BARANOF INTERBAY STORAGE

DRB Recommendation Presentation #3

Meeting Date 10/19/2016
SDCI PROJECT # 3022095

2.0 REC BOARD COMMENTS + ITEMIZED RESPONSES

7.0 FLOOR PLANS

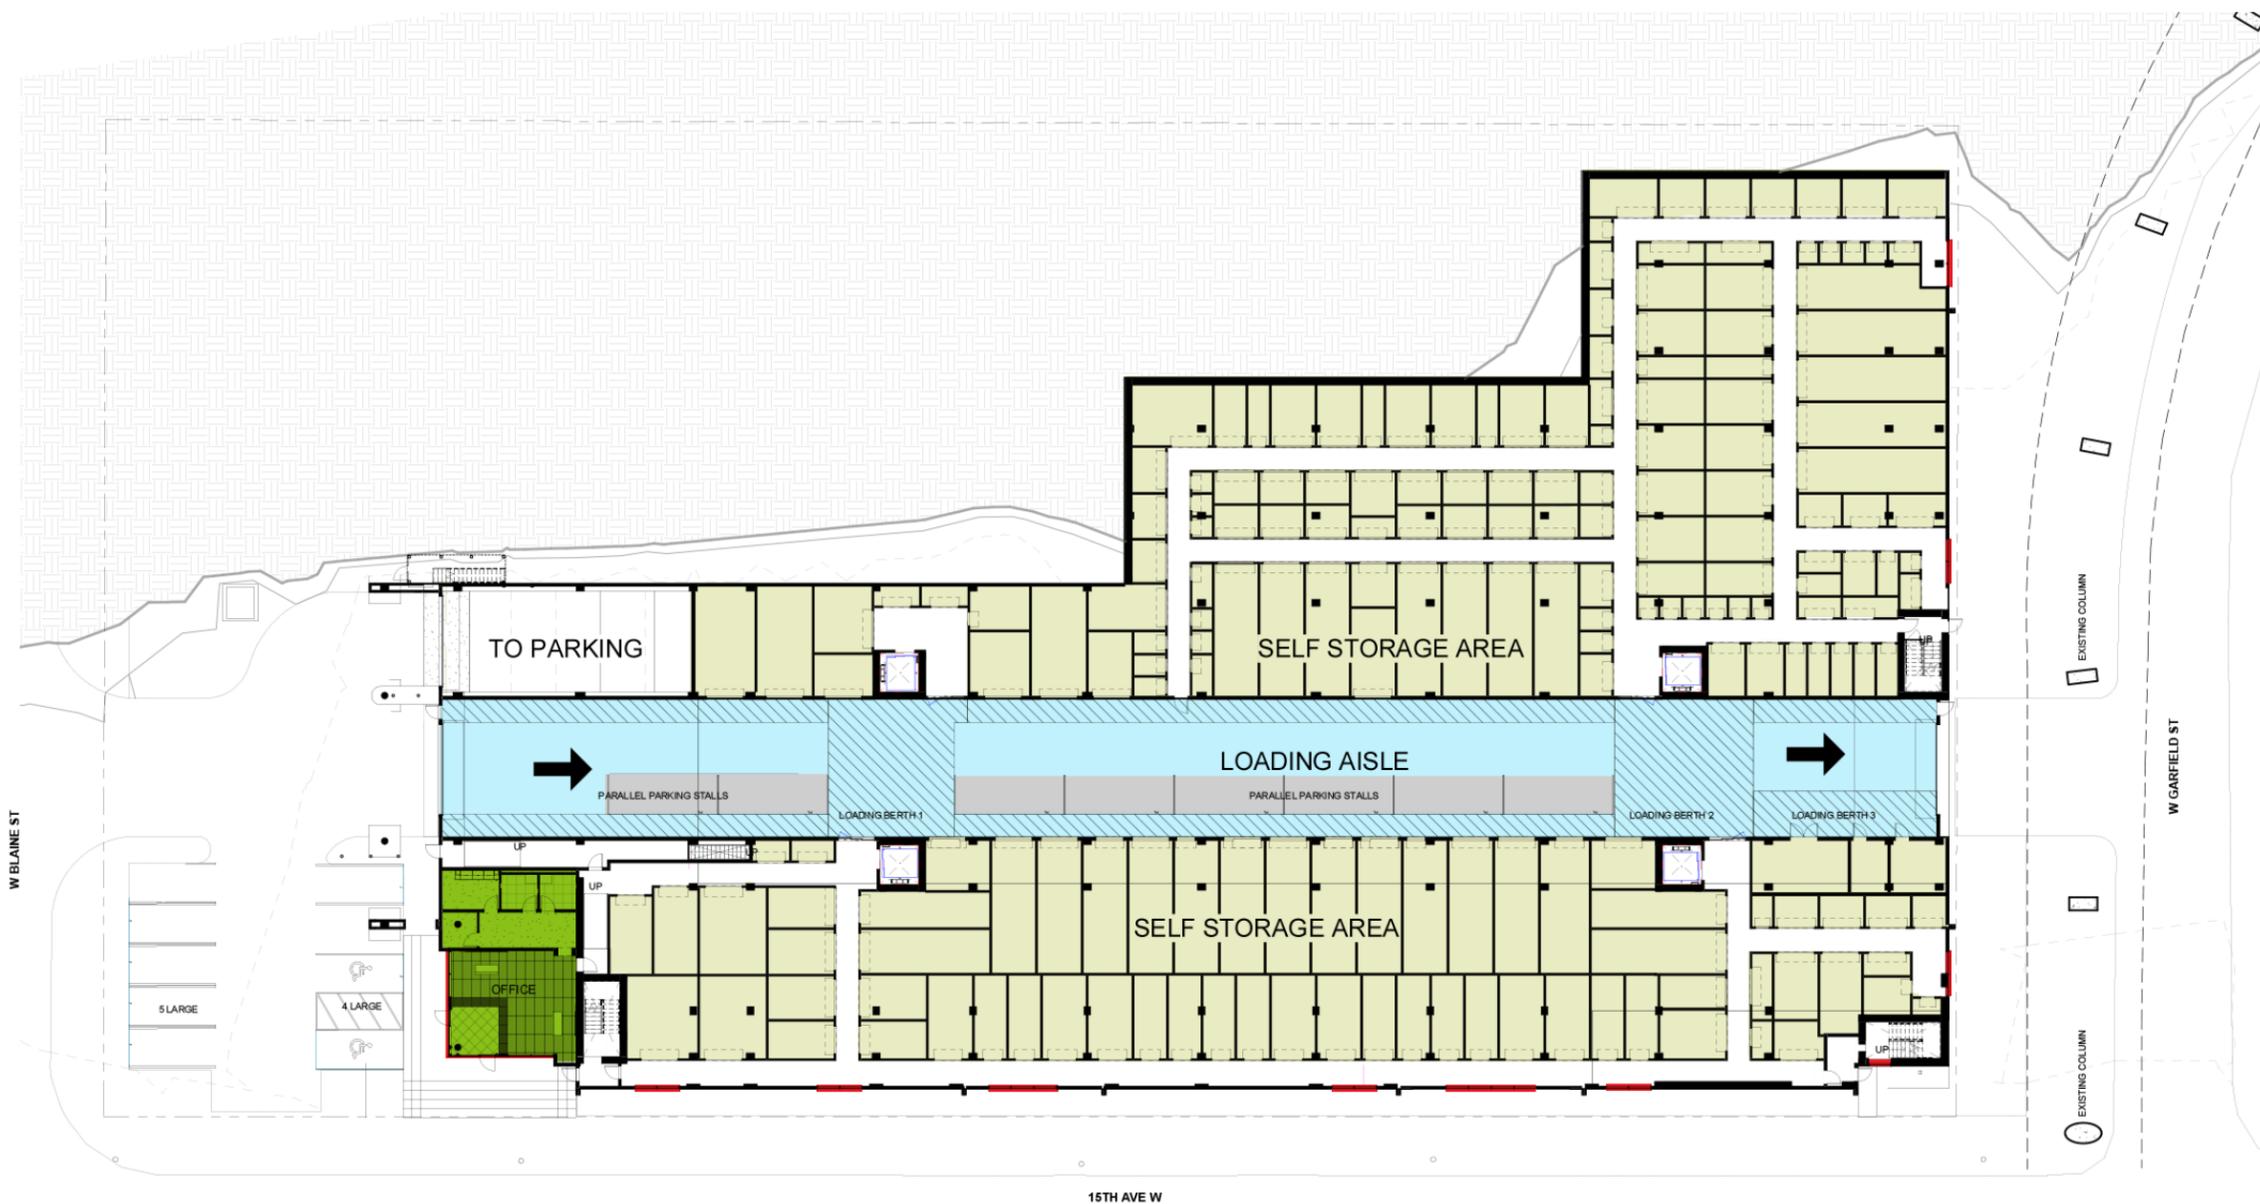
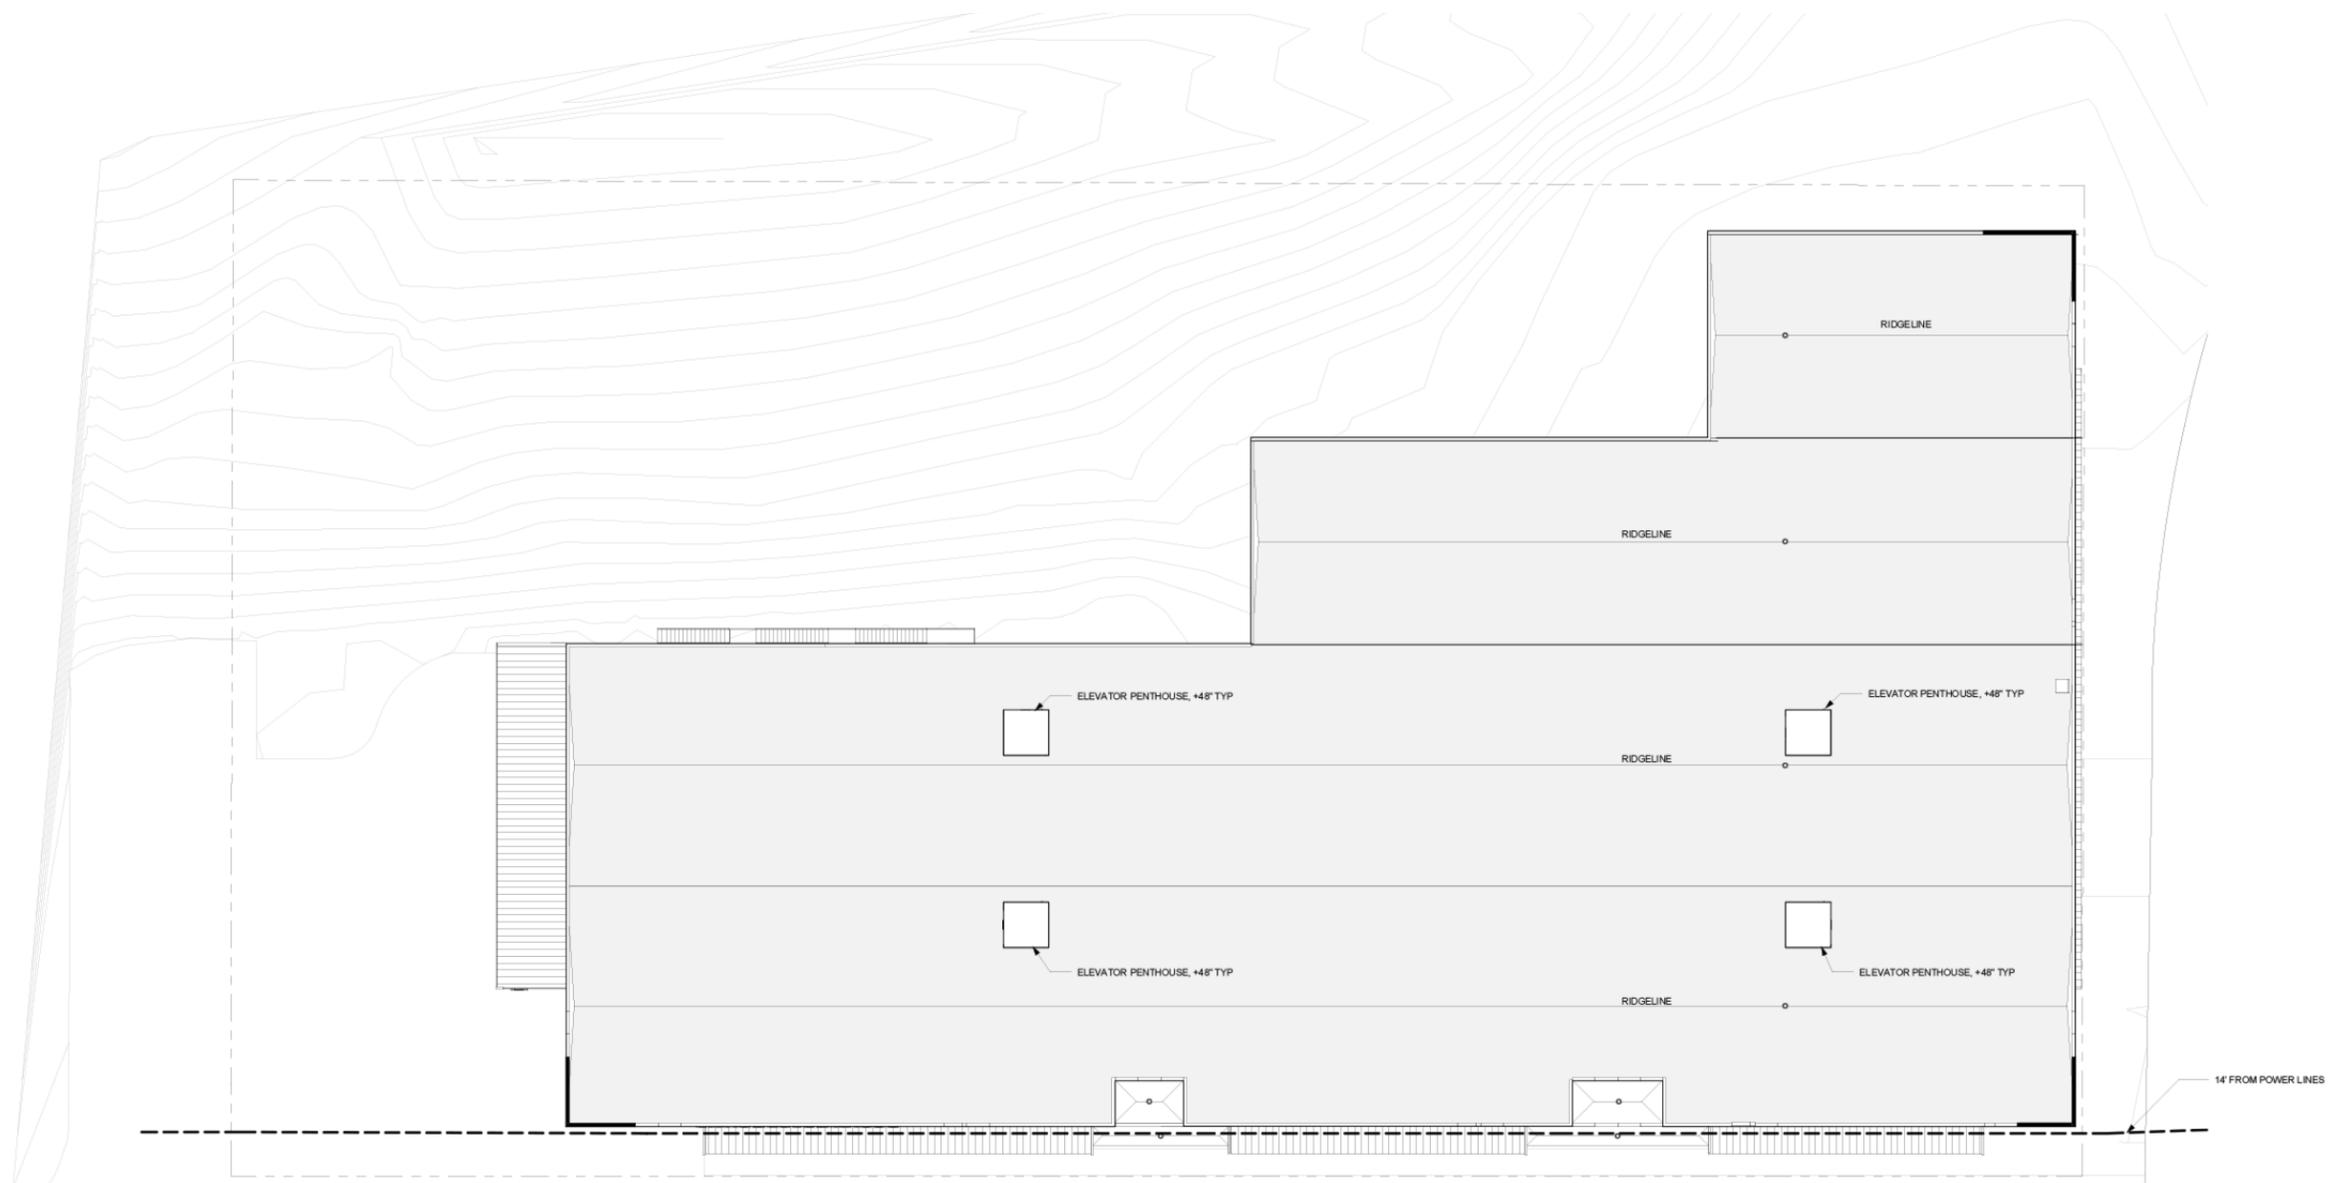
d. The Board questioned the relationship between the interior functions and treatment of the west elevation. The floor plans should match the elevations to clearly articulate interior and exterior relationships.

e. The Board recommended the windows line up with corridors. The Board specified that display cases are not acceptable. The elevations should show the storage doors inside.

The requested clarifications have been addressed in both the elevational diagrams and updated floor plans. Both articulate the relationship of active space to the glazing.

The requested clarifications have been addressed in both the elevational diagrams and updated floor plans. Both articulate the relationship of active space to the glazing.
